Adur Planning Committee			
Date:	4 March 2024		
Time:	6.30 pm		
Venue:	QEII Room, Shoreham Centre, Shoreham-by-Sea

ADDENDUM

Application Number:	AWDM/0970/23 & AWDM/0163/24	Recommendation - Approve	
Site:	42 Brighton Road, Lanci	ng	
Proposal:	construction of a over 3 levels with works. New outbui south. New detach over and cycle sto Vary Condition 1 approved AWDM/05 in height of house balconies to front to front. Increase 0.37m; addition of construction dwelling over 3 associated works. terrace to the sour guest bedroom over Application to Vary previously approve Inclusion of a trelling over 3 associated works.	levels with rear terrace and New outbuilding with raised th. New detached garage with er and cycle store to the north. Condition 1 (approved plans) of d AWDM/0923/21. Amendments: is/privacy screen along the area the sunken seating as part of	
Applicant:	Mr Bernard	Ward: Widewater	
Agent:	Domus Architecture Ltd	vara. vvidewater	
Case Officer:	Peter Barnett

This objection letter relates to application AWDM/0163/24, which is a section 73 application to alter the plans attached to AWDM/0923/21 at 42 Brighton Road, Lancing, West Sussex, BN15 8ET.

Images showing ground level of No. 44 to the left, and the raised ground level of No. 42 to the right.

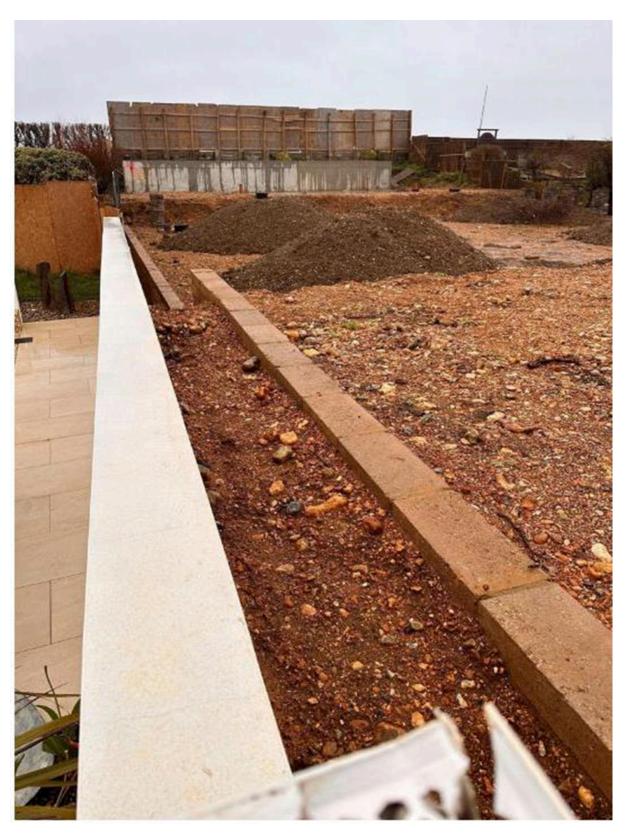
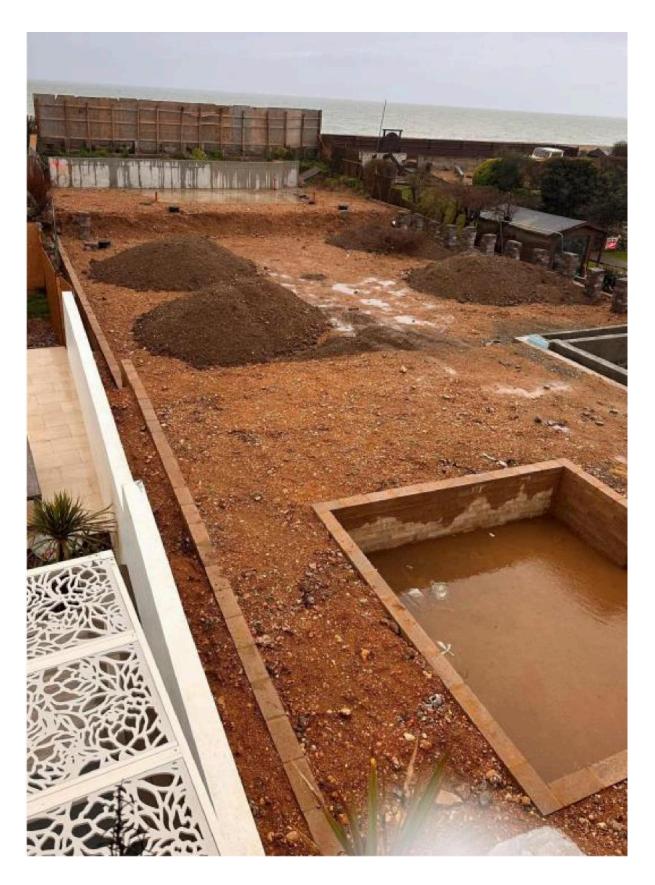
Due to the unlawful alterations made to the ground levels of the proposal site, the rear garden of the application site sits significantly higher than that of No. 44. The proposal seeks to limit the impact of the significantly raised ground levels by the slight set back of the wall from the site's boundary, and the imposition of a hedge between the wall and No. 44. However, this would still result in a significantly tall boundary feature, sitting significantly above the existing boundary wall of No. 44 (extending around 12ft above the garden level of this dwelling), resulting in significant residential amenity impacts through overbearingness and overshadowing. The images below show the new, raised ground level of No. 42, in comparison to the top of the boundary wall of No. 44; it is clear that the provision of another boundary at the new, raised ground level would result in significant overbearing and loss of light impacts to the residents of No. 44.

It is considered that the garden heights should be revisited in line with Condition 10 of the original application, which would allow the residential amenity of the occupiers of No. 44 to be retained, without any excessive overlooking or exceedingly tall boundary features directly next to their living areas.

It is considered that the significant residential amenity impacts from the current application would remain, and as such, the proposed alterations would not comply with Policy 15 of the Adur Local Plan 2017 or Paragraph 127 of the NPPF and as such, should be refused.
